## MITIGATED NEGATIVE DECLARATION

**Project Title:** 2004.0220E – 1840 Washington Street Residential Development

**Project Address:** 1840 Washington Street

Figure 3  
Basement Floor Plan

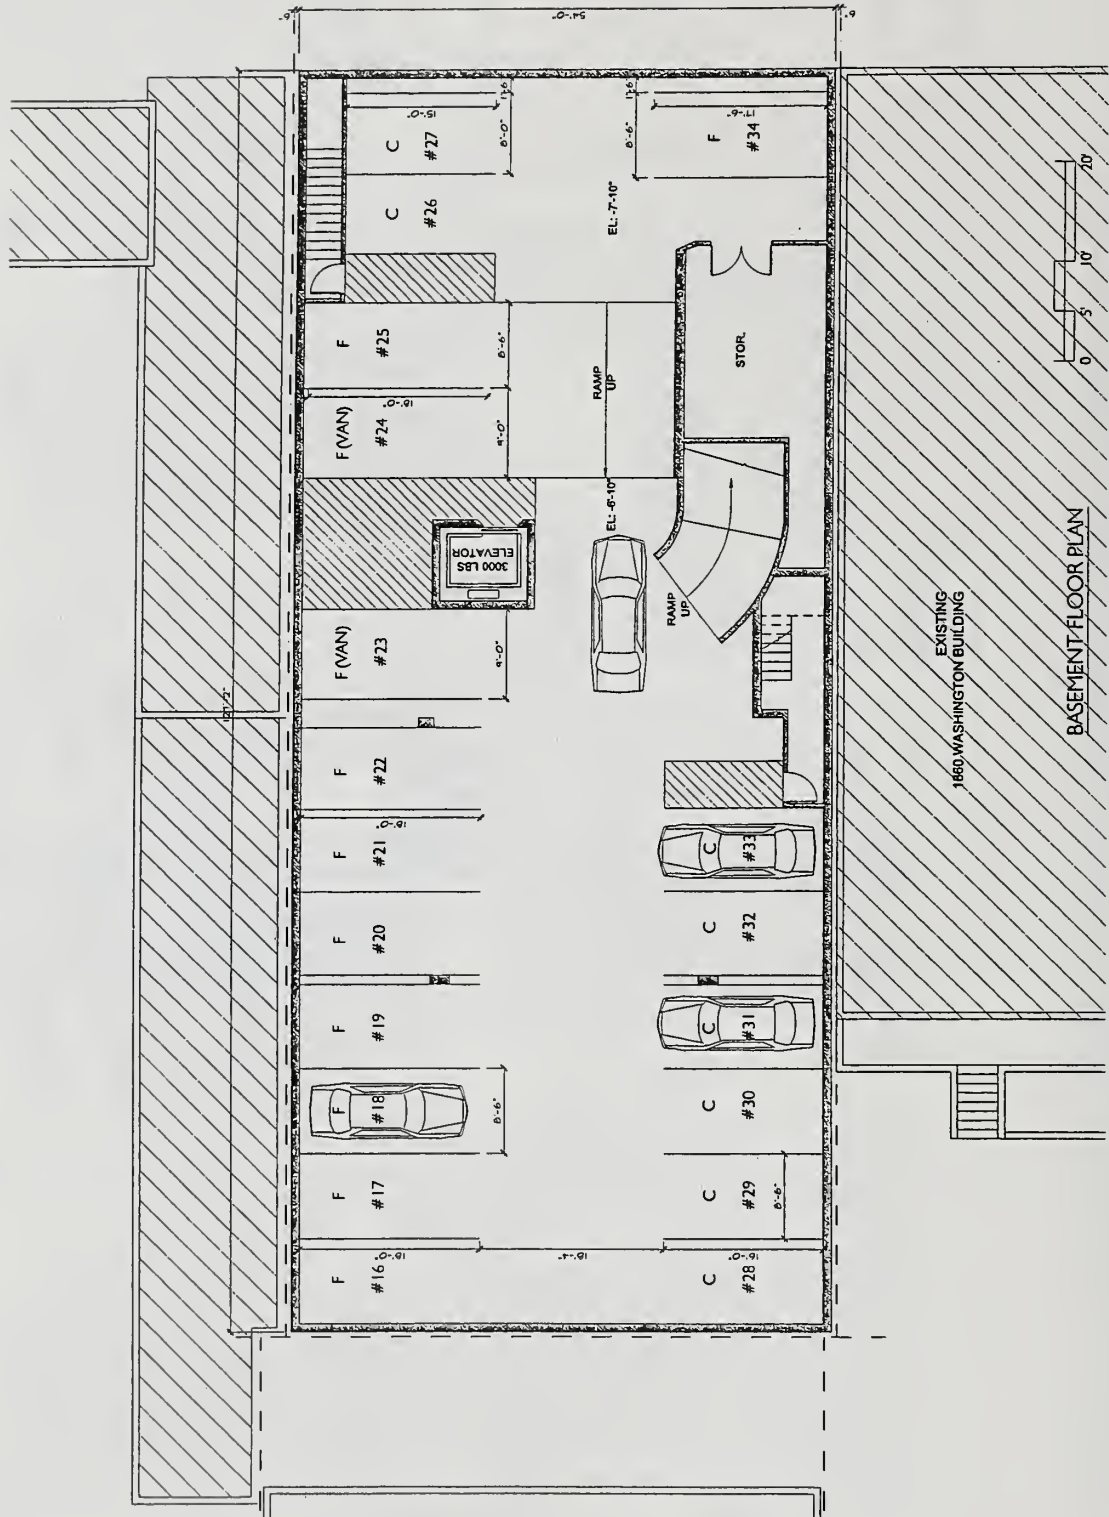
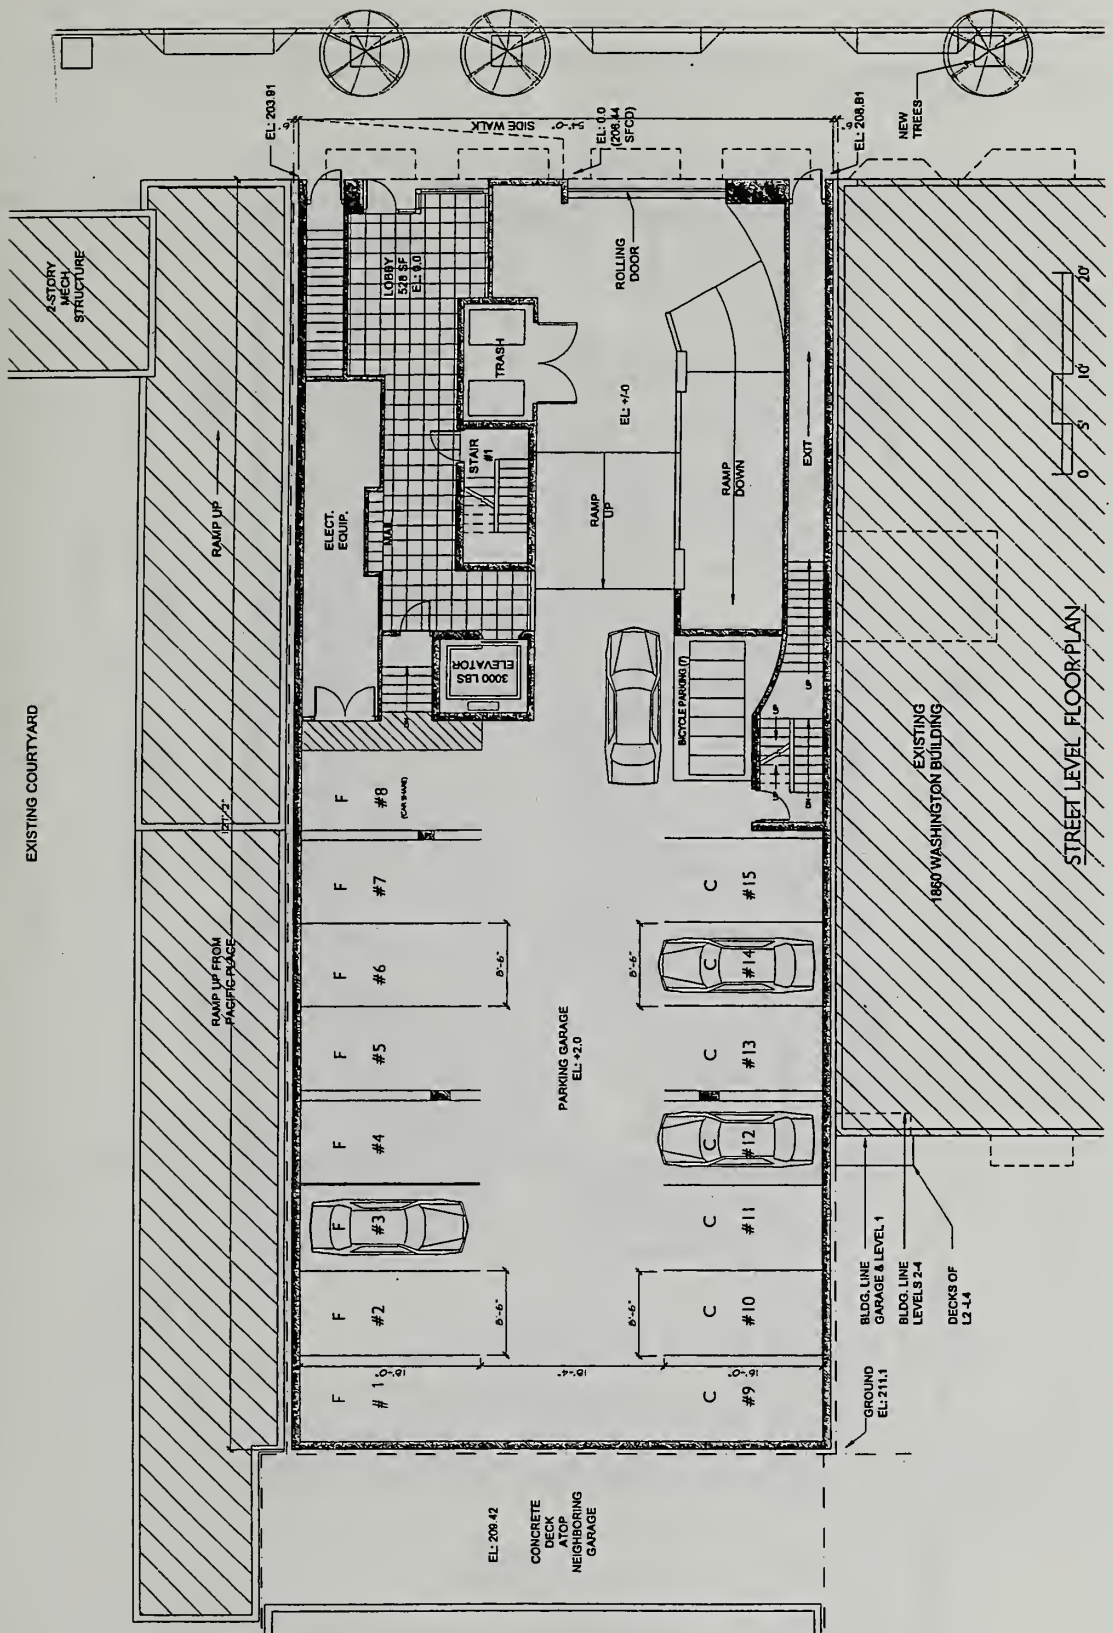
**Response No. 8:** Full sized spaces are shown in both the original Figures 3 and 4 of the PMND, and the revised Figures 3 and 4 included in the PMND, as Amended. The original figures showed 19 full sized off-street parking spaces, 14 compact spaces, and two full-sized van spaces. The revised figures show 17 full-sized off-street parking spaces, 15 compact, and two full-sized van spaces.

Figure 1  
 Shadow Diagrams - September 21 2:00pm PDT  
 1840 Washington Street  
 San Francisco, California

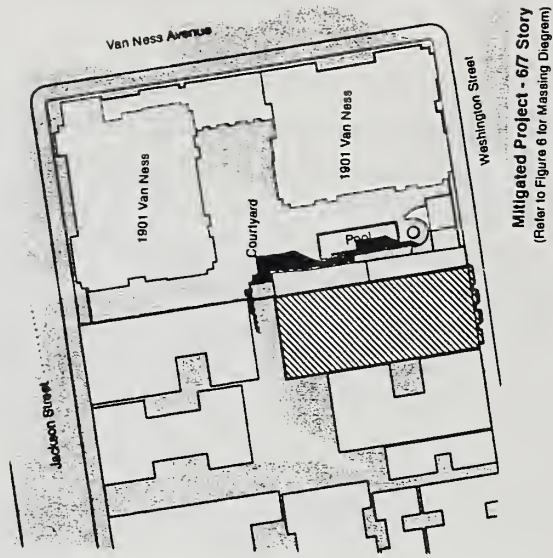
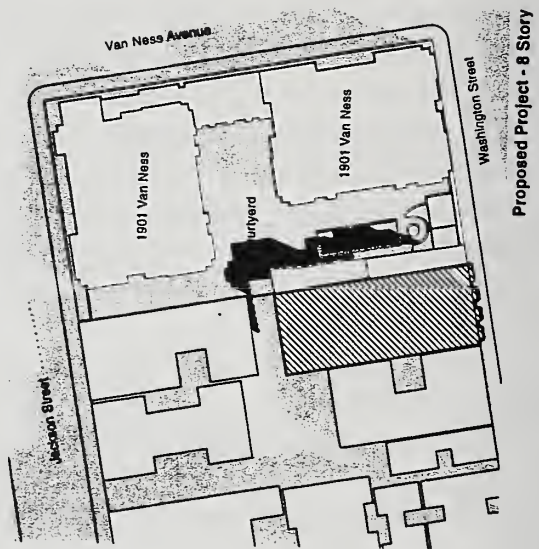
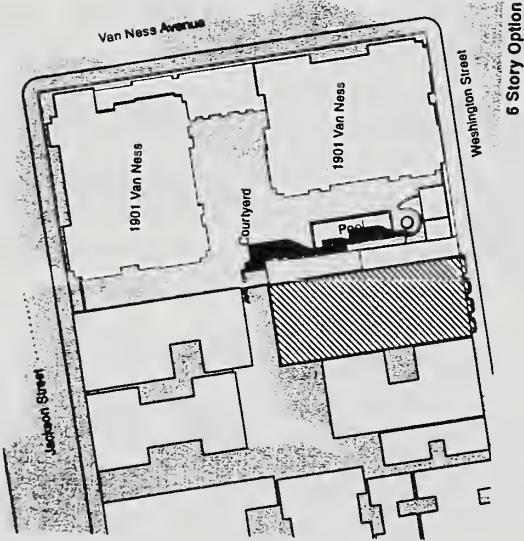
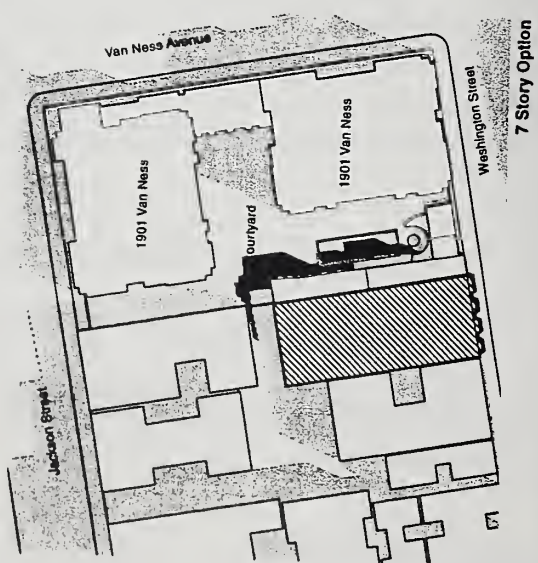
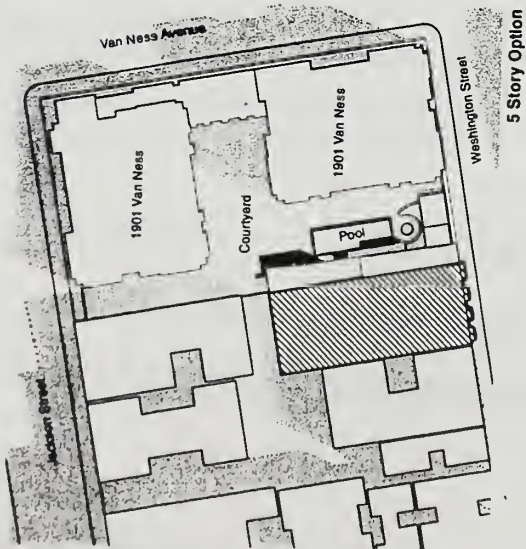
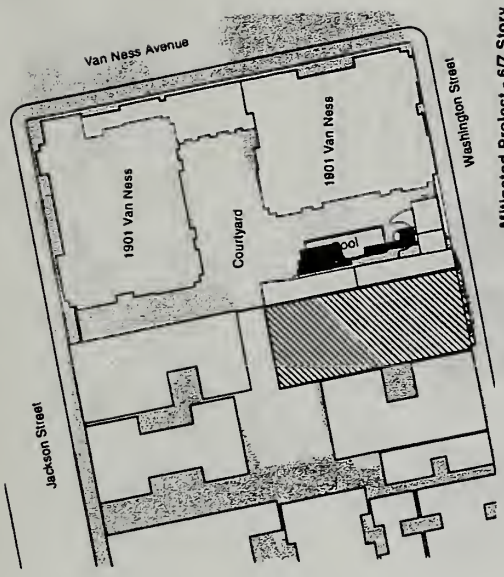
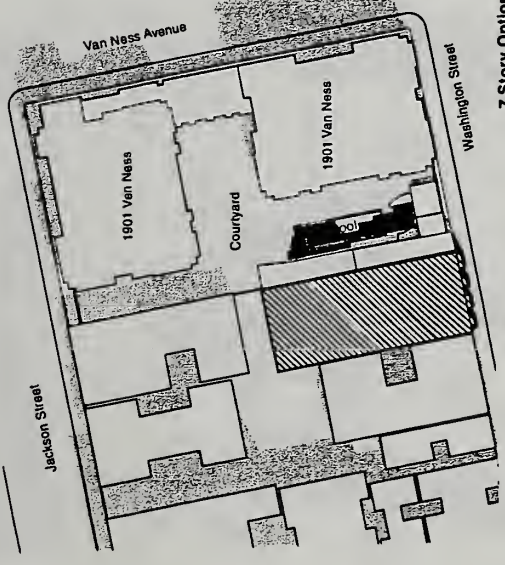
Comparison of the diagrams on Figure 1 indicates the varying amounts of shade that would be cast on the swimming pool itself during September at 2pm. At this time the eight-story building would shade virtually the entire swimming pool while the six-story building would shade only about half the pool area. Similarly, a comparison of the Figure 2 diagrams demonstrates that about half the pool would be shaded by a six-story building at 3pm in June whereas an eight-story building would cast shadow on almost the entire swimming pool area. The diagrams also indicate that with respect to shadow effects on the pool itself, the stepped-back 6/7-story building and the six-story building are comparable.
